# Addendum 2

DATE	01/23/2026
PROJECT NAME	BL572 – Intercollegiate Athletics Gymnasium – Replace Chiller, Heating Systems and Controls
INTROBA PROJECT #	2035.0013084
IU PROJECT #	20240613
DISTRIBUTION	Owner
ADDENDUM CONSIST OF	(1) 8.5 x 11 PAGES & (9) 30 x 42 PAGES

1 STRUCTURAL PLAN BL572 LEVEL 2 BASE BID

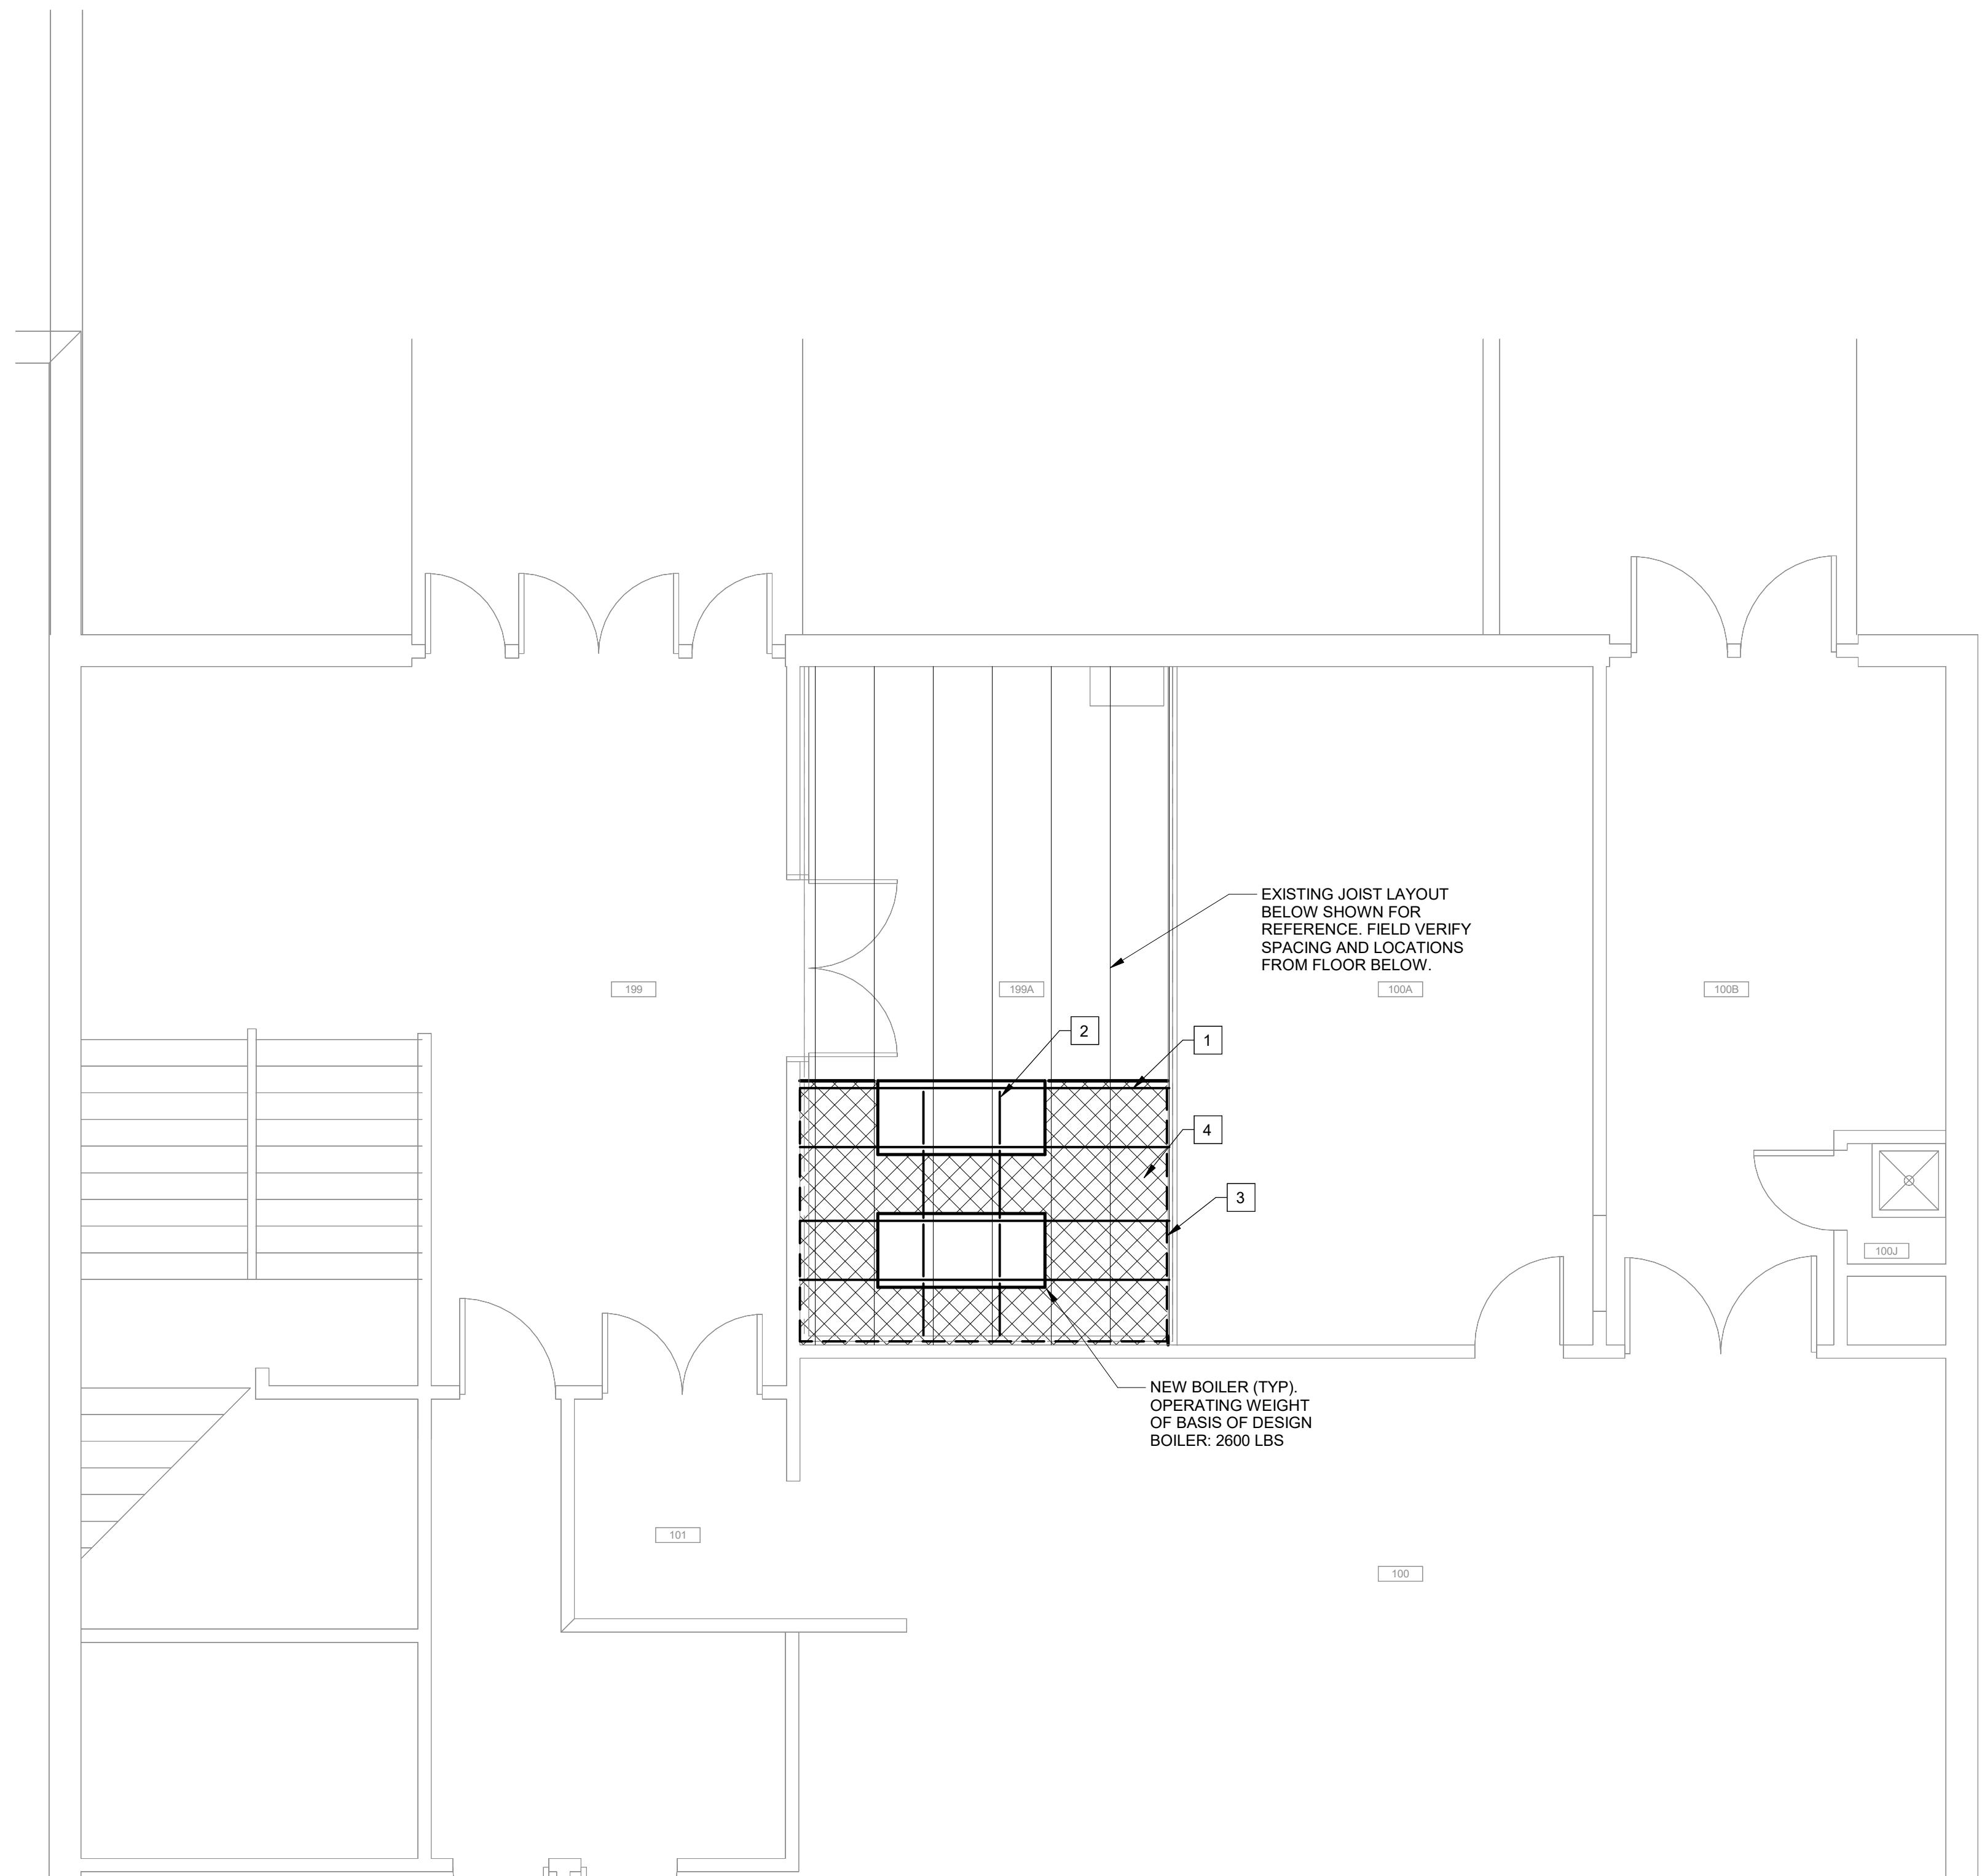
1. S-101 – STRUCTURAL PLAN BL572 LEVEL 2 BASE BID
  - a. Added in its entirety.

1. W8x15 (TYP-4) T/STEEL 0'-8". ALIGN BEAMS WITH WEB/TOP CHORD INTERSECTIONS OF JOISTS BELOW. MOST NORTERN BEAM TO BE PAINTED OSHA APPROVED YELLOW.
2. W4x13 (TYP-8) T/STEEL 0'-8". COORDINATE LOCATIONS WITH BOILER BASE FRAME.
3. TS8x2x1/4 AS REQUIRED FOR GRATING SUPPORT AT FREE EDGES.
4. 19-W-4 GRATING WITH 1-1/4x3/16 BARS. GRATING TO BE PAINTED OSHA APPROVED YELLOW.
